MEMO

DATE December 15, 2023 **PROJECT NO.** 2583-6916
Memorandum
RE Driveway Spacing for 304 & 318 Spruce Street
Town of Oakville, Halton Region

Pre-Consultation Comments Report

Concept Plan

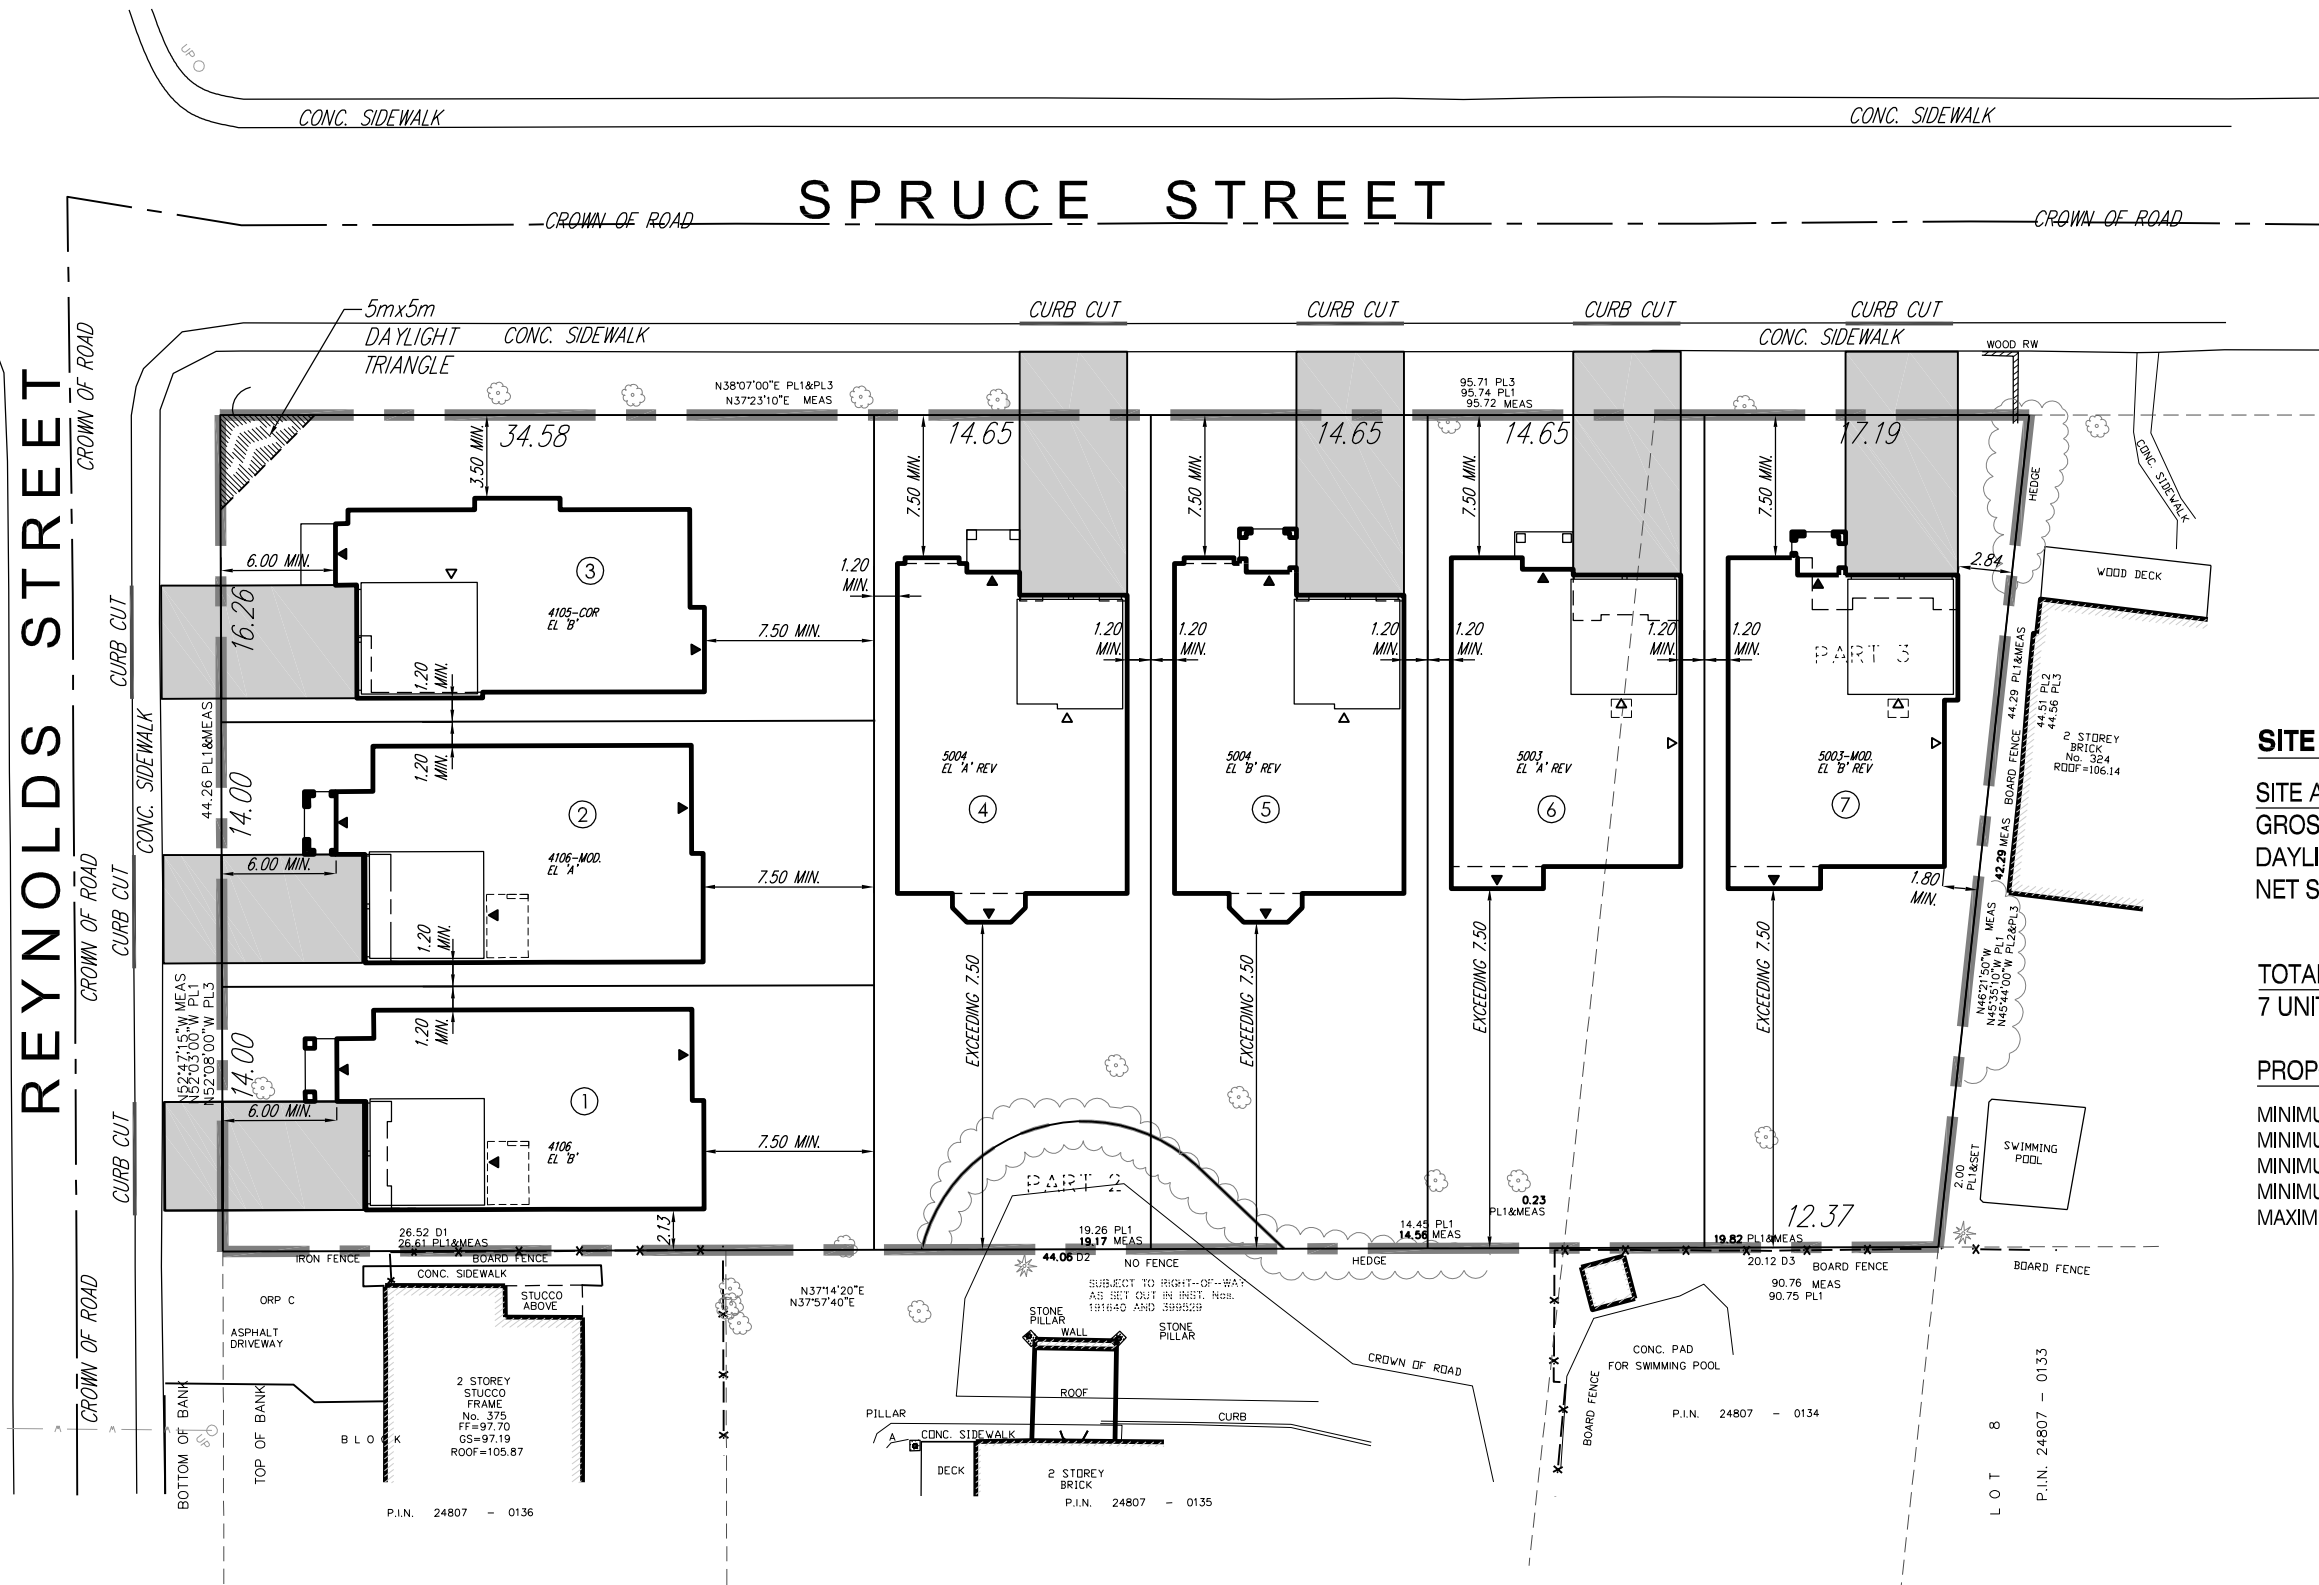
Access to access spacing is the distance between existing or possible future driveways. The required and provided spacing per Figure 8.9.2 in TAC GDGCR are summarized in **Table 1**. The driveway numbering can be seen in **Attachment 1**.

The access to intersection spacing is the distance between site driveways and intersections. The minimum spacing requirement is made up of the tangent section C (2.0 m) and the corner curb radius (4.5 m), which comes out to a spacing of 6.5 m. The required and provided spacing between the driveways and the nearest minor intersection as per Figure 8.9.2 in TAC GDGCR are summarized in **Table 2**.

All of the driveways for the development are expected to have adequate spacing.

The spacing between driveways and the minor intersection at Spruce Street and Reynolds Street meets the TAC requirements.
